Subject: Docket Submission of Meeting with Robert Bosch LLC

To: Docket Number: NHTSA-2023-0021 Light Vehicle Automatic Emergency Braking

### NHTSA NPRM AEB and PAEB Bosch Comments Highlights

#### **AEB Maximum speeds**

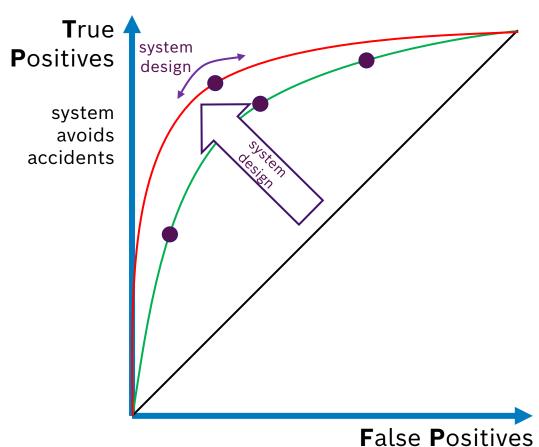
Achieving collision avoidance at higher relative velocities is nearing the technical feasibility of current series production technology.

- Increasing AEB/CIB relative velocity reduction to 80kph may lead to more "false positives"
- Suggested reductions to address these challenges: AEB/CIB to 60kph and EBA/DBS to 70kph

### Bosch Comments Warning dilemma of FCW

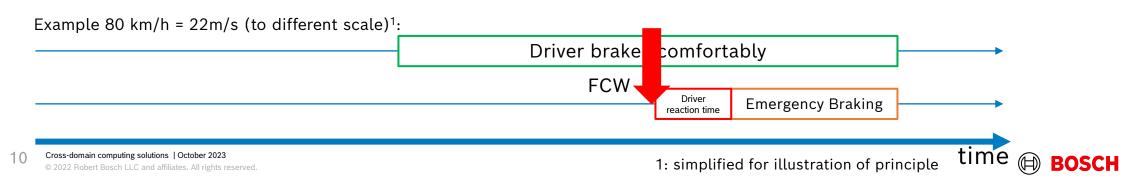
• Low speed – FCW before planned action of typical driver

### no FCW at low speeds (less than ~30kph)

High speed – FCW after a possible planned action of typical driver
 use FCW for high speeds (more than ~30kph)

### Bosch Comments Repetition of tests for both AEB and PAEB

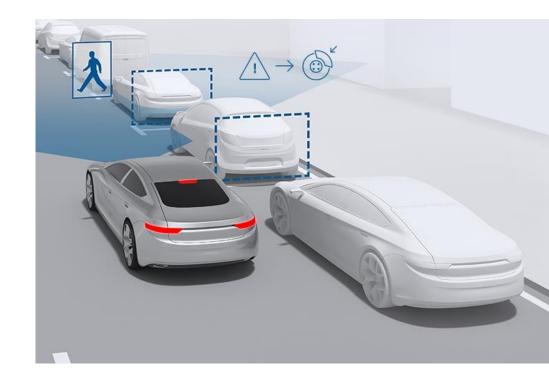
#### **Repetitions of tests**

• Multiple repetitions of a scenario as well as collision mitigation instead of avoidance at higher velocities should be allowed (e.g., 2 out of 3, or 5 out of 7)

- Mandating many test cases that all need to be passed in a single test run might lead to problems for vehicles with otherwise good AEB systems.
- Due to the nature of systems relying on environment sensors the probability to pass a test is (slightly) lower than 100%.

#### Mannequin appearance

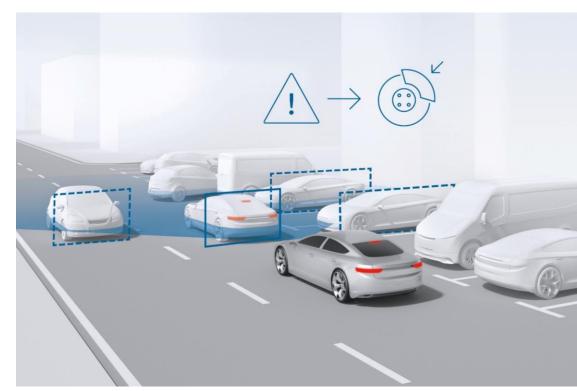
- Outline of the NHTSA-approved testing equipment
  - Requirements for pedestrian testing equipment, specify the approved platforms, such as belt systems and launchpads, and the corresponding approved manufacturers of the devices
  - Use only the latest test targets (acc. to ISO 19206)
